Design and Access Statement Appendix A

Design Analysis of alternative siting of dwelling

New Passivhaus dwelling at Tower Street, Barnsley which is accessible and adaptable to the requirements of M4 Category 2

1. **PLANNING RESPONSE TO APPLICATION REF: 2024/0112**

Cover - Elevation to Tower Street

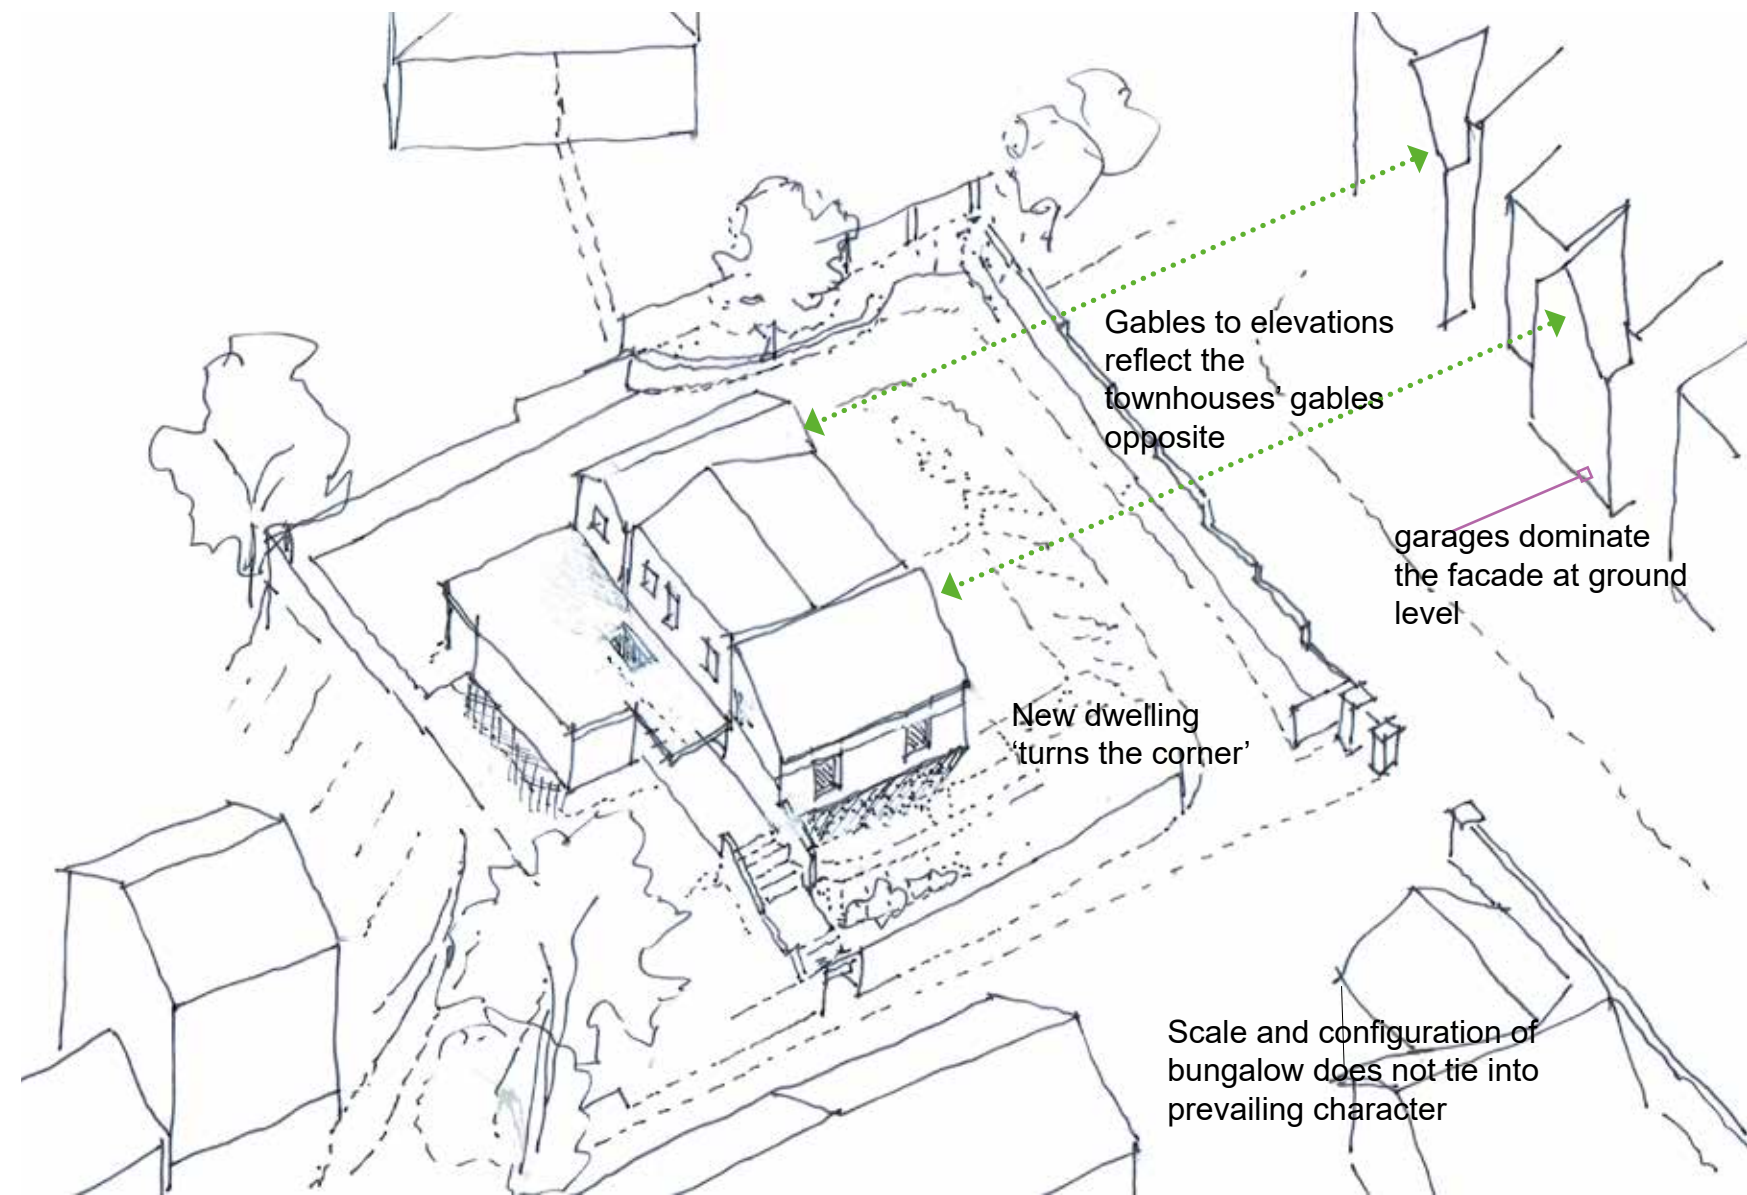
This application proposes 1 dwelling rather than 2 and has a very modern appearance when compared to the previous permission and the dwelling granted at the opposite site. All of the neighbouring properties (including the approved dormer bungalow opposite) are finished in stone; have a traditional architecture and follow a prevailing build line.

On this basis, I am not convinced that the style of dwelling hereby proposed is acceptable. The dwelling would appear alien within the street scene and would harmfully disrupt the character of the street. The use of steel cladding is not appropriate and fails to reflect nor reinforce the local characteristics and building traditions, as required by Local Plan Policy D1. The orientation of the dwelling, ie perpendicular to the highway, is also at odds with the prevailing character, adding to its incongruous appearance. The scale of the dwelling should be reduced so it is more akin to the dormer dwelling approved at the opposite site. The recent pre-application advice letter clearly states 'it is recommended that amendments are made to provide a more traditional design, scale and materials in location..'. Please can you discuss these alterations with your client and provide amended plan to reflect this.

In response to the points raised below, whilst I recognise the applicant's desire to construct a more contemporary and eco-friendly style dwelling, I am not convinced that this is appropriate at the application site. I still consider that the frontage needs to have a more traditional appearance. Although the door is positioned to face Tower Street, this elevation lacks interest and appears fairly blank consisting of just 1 narrow window. This fails to reinforce the local characteristics or appearance of the street

scene. I would strongly advise that the orientation of the dwelling is revisited so the dwelling follows the established street pattern.

We have revisited the design of the street elevation, and we believe that the drawing shown above clearly demonstrates how comfortably the proposed dwelling sits within the streetscape. We also demonstrate with the addition of another window to this elevation and an adjustment to the proportions that we have followed the blueprint of the terrace house windows, with stone lintols and cill details as well as proportion. The elevation is further reinforced with a stone boundary wall base, reflecting the stone walls of the townhouse development.

The negative reference to 'modern appearance' does not seem correct due to the fact that the street elevation of the proposed dwelling is far more in keeping with the traditional terrace houses than any of the more recent additions to the street.

The materials used are natural stone (rather than artificial stone used on the townhouses), a slate roof and more detail has been added around the windows with dressed stone lintols, cills and jambs. We have also previously submitted a study and contextual photos showing how this reflects the openings in the immediate surroundings.

The use of another facing material, a standing seam steel cladding, is confined to the side elevations and is not visible from oblique angles along the street. We feel that the change in material at first floor in small areas gives an articulation to the facade and creates a more interesting design. We do not think this material detracts from the traditional elements along the street.

WARM PHPP Results Sheet - Main Results

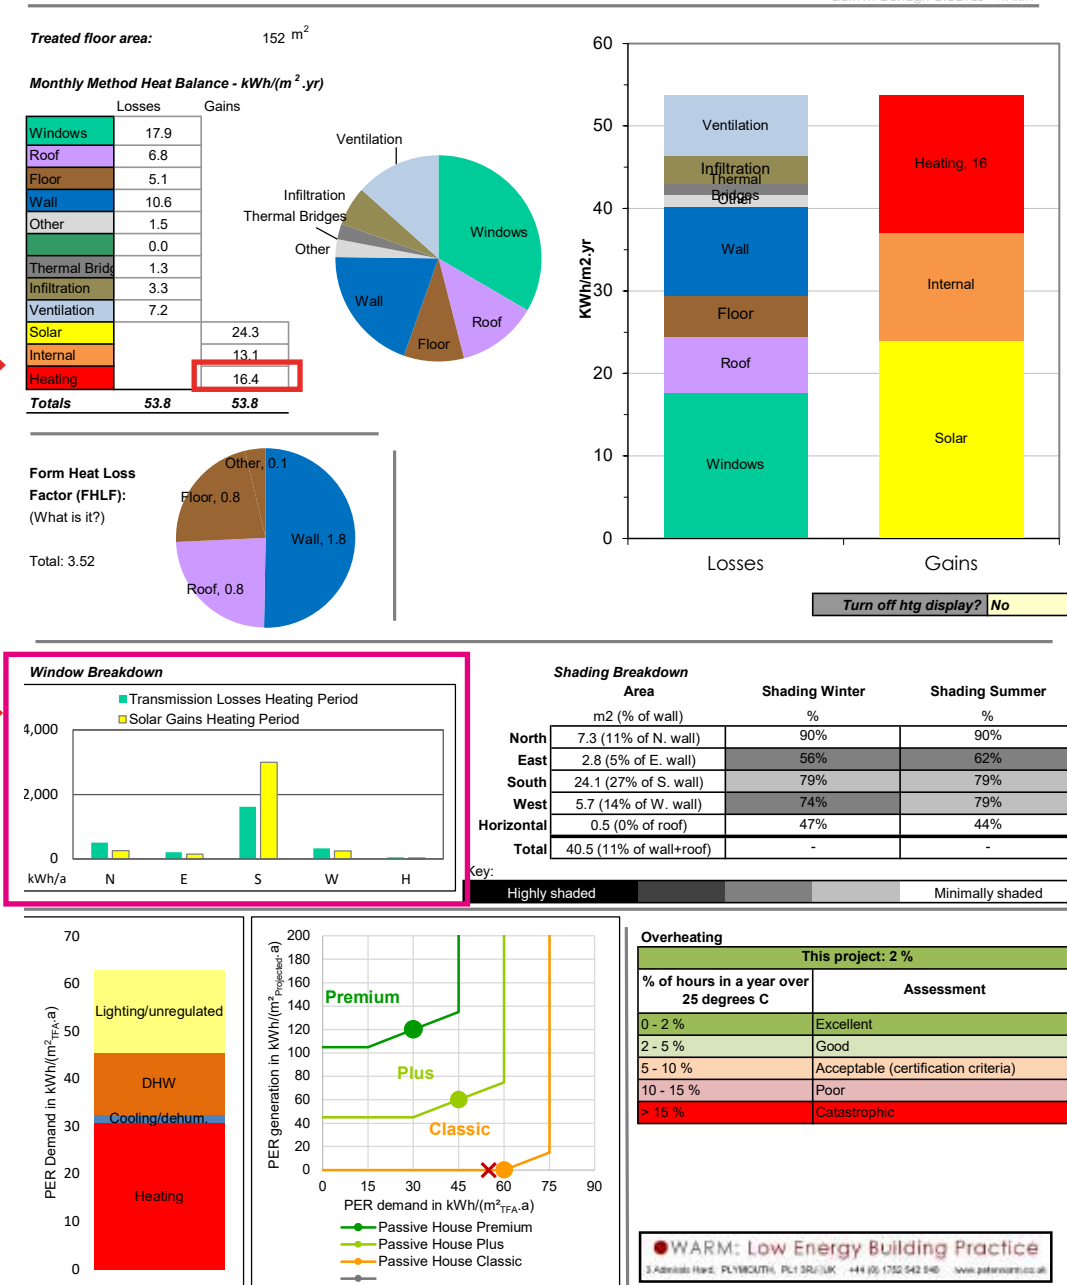
As stated in our emails, one reason for the building orientation is to maximise beneficial solar gains during the heating season and is part of the Passivhaus Strategy

We have carried out full calculations using the Passivhaus Planning Package, the results

are shown above (as designed). The results (indicated above) equate to an annual energy demand of **16kWh/m2/a**. The solar gains that are utilised in passive design on the south facing windows are shown on the graph highlighted.

WARM PHPP Results Sheet - Main Results

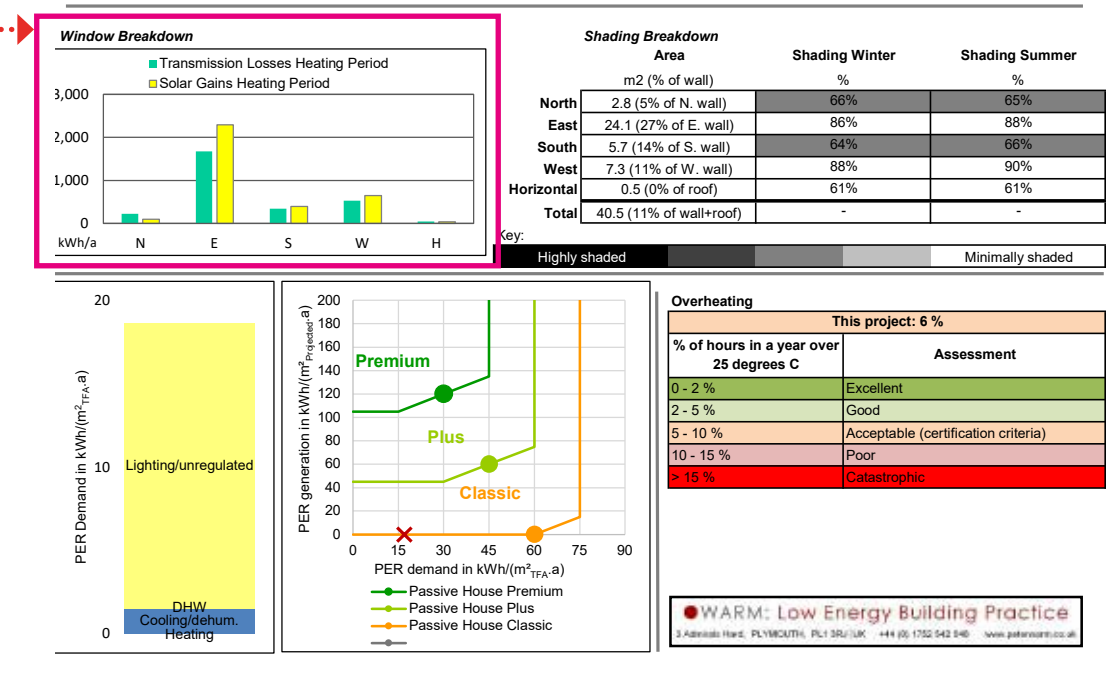
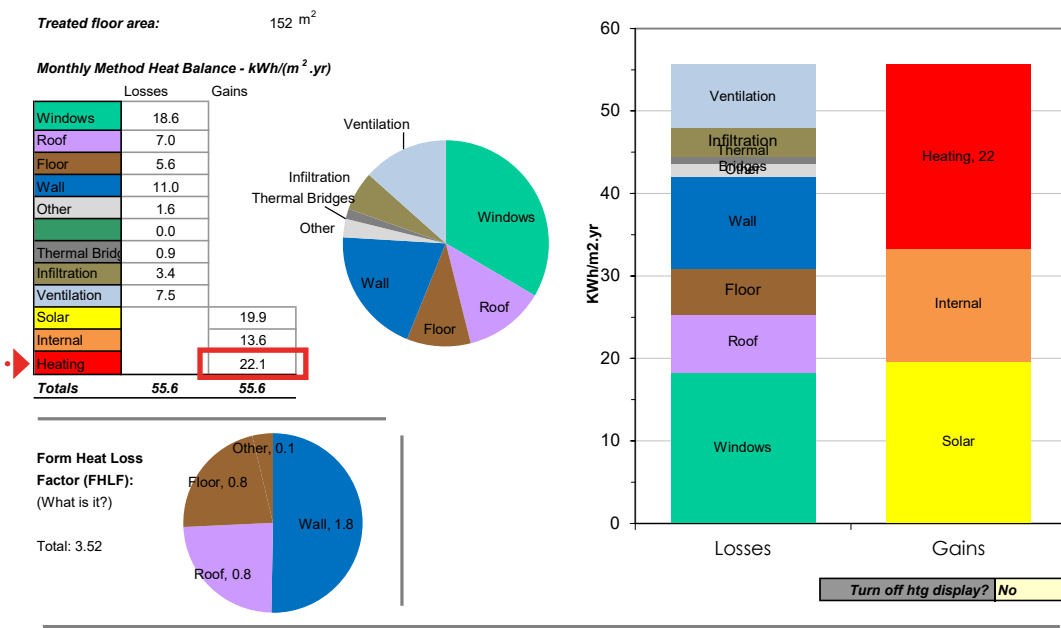
3. EVALUATION - ORIENTATION OF LONG ELEVATION PARALLEL TO TOWER STREET

The results of the PHPP calculation show that the annual energy demand increases to 22.1kWh/m2/annum. This is an increase of **37.5%** per year.

This is due to less windows facing south and the solar gain to the east facing windows being only marginally greater than the transmission losses.

WARM PHPP Results Sheet - Main Results

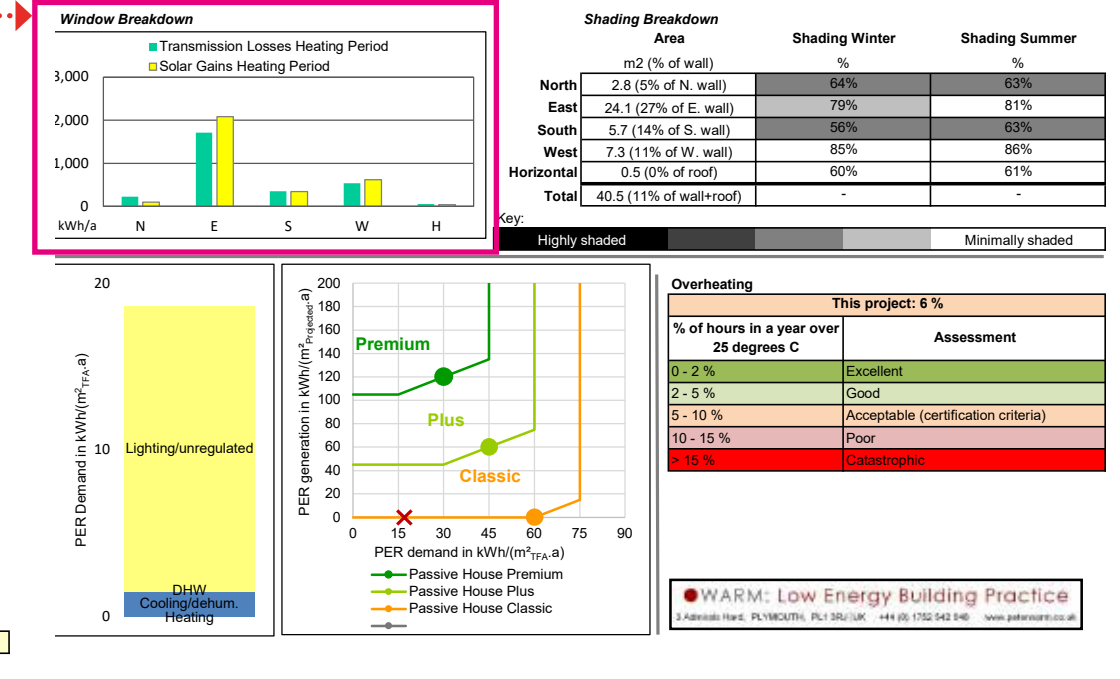
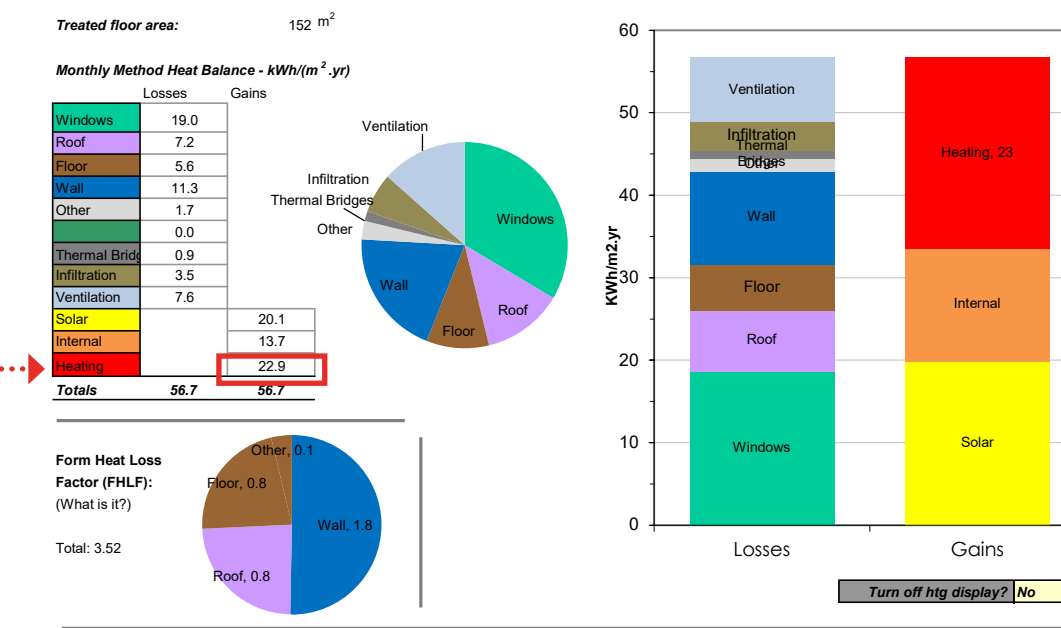
4. EVALUATION - ORIENTATION OF LONG ELEVATION PARALLEL TO TOWER STREET AND REDUCED LEVELS

The results of the PHPP calculation show that the annual energy demand increases to 23 kWh/m2/annum. This is an increase of **43.75%** per year.

For this case the solar gains are reduced even further due increased shading on the windows to the east. Overshadowing is caused by the rear garden boundary at higher levels.

Reducing the level of the dwelling also results in an additional 630m³ of soil to be removed from site. For environmental reasons as well as disruption on the site, we do not consider this option to be satisfactory.
